MIL "ON" DTC P0418/P244# Air Pump Filter Debris

Service Category Engine/Hybrid System

Section Emission Control

YEAR(S)	MODEL(S)	ADDITIONAL INFORMATION
2010 – 2013	GX460

D. Install air pump cover by attaching the 3 claws. **Figure 1.**

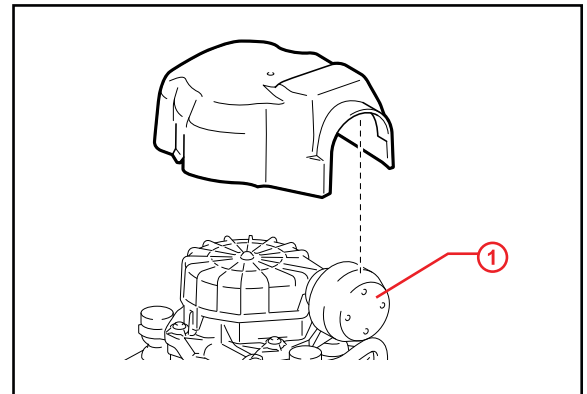
Make sure the inlet of the air pump cover is oriented correctly and completely attached when installing the air pump cover.
